MCF5329 Chip Errata

Silicon Revision: All

This document identifies implementation differences between the MCF532x processors and the description contained in the *MCF5329ColdFire® Reference Manual*. Refer to <http://www.freescale.com/coldfire> for the latest updates.

Figure 5. Qualifying multiple chip selects using a buffer

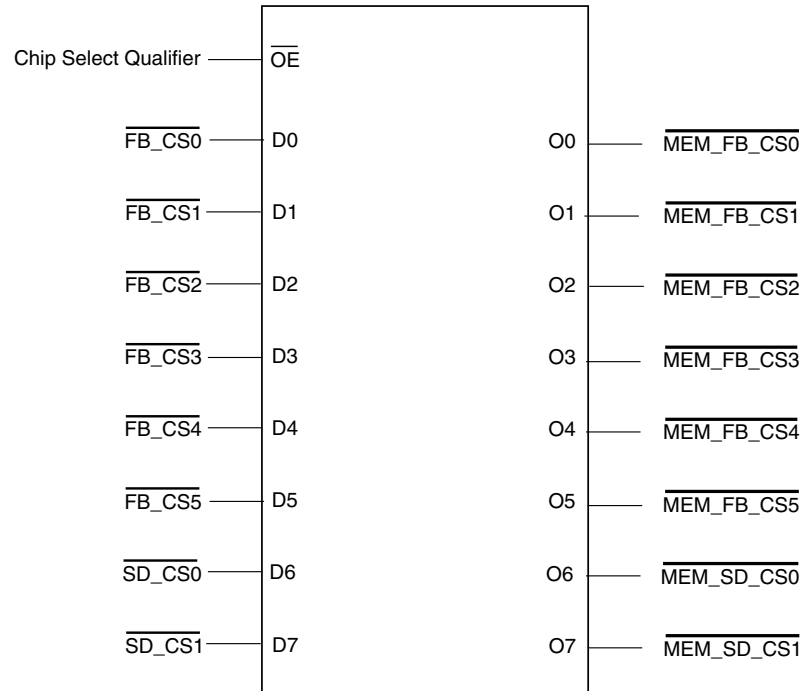
Workaround: The undefined pin states occur only during a power-on reset (POR), the $\overline{\text{RESET}}$ and/or $\overline{\text{RSTOUT}}$ signals can be used to qualify FlexBus and SDRAMC signals. In most cases, the only signals that will need to be qualified are the FlexBus chip select and SDRAM chip select signals. By using qualified versions of the chip selects to connect to external devices, you can prevent those external devices from sampling the undefined pin states on address, data, and other control signals.

The first step to the workaround is to generate a signal that can be used to qualify or mask the undefined signal states on the chip select signals (or other control signals as needed). Determining the qualifier to use can require some characterization of power and reset signal operation in the system. The idea is to find a signal or combination of signals that remain high around the time when the undefined signal states can occur.

The second step of the workaround is to use the qualifier signal generated to qualify or mask chip select signals to external devices as needed.

In the diagram above “MEM_” is used to differentiate the chip select signals from the processor and the qualified versions that would be connected to external memories. Each of the “MEM_” signals should include a pullup resistor to force the signal high while the buffer is disabled.

Fix plan: This issue has been fixed starting with the 6M29B mask set. The fix that has been implemented ensures that $\overline{SD_CS}[1:0]$ and $\overline{FB_CS}[2:0]$ will either drive high or float during reset. These pins will never driver low during the reset sequence. The operation of $\overline{FB_CS}[5:3]$ is unchanged. The state of $\overline{FB_CS}[5:3]$ can still be undefined during the reset sequence.
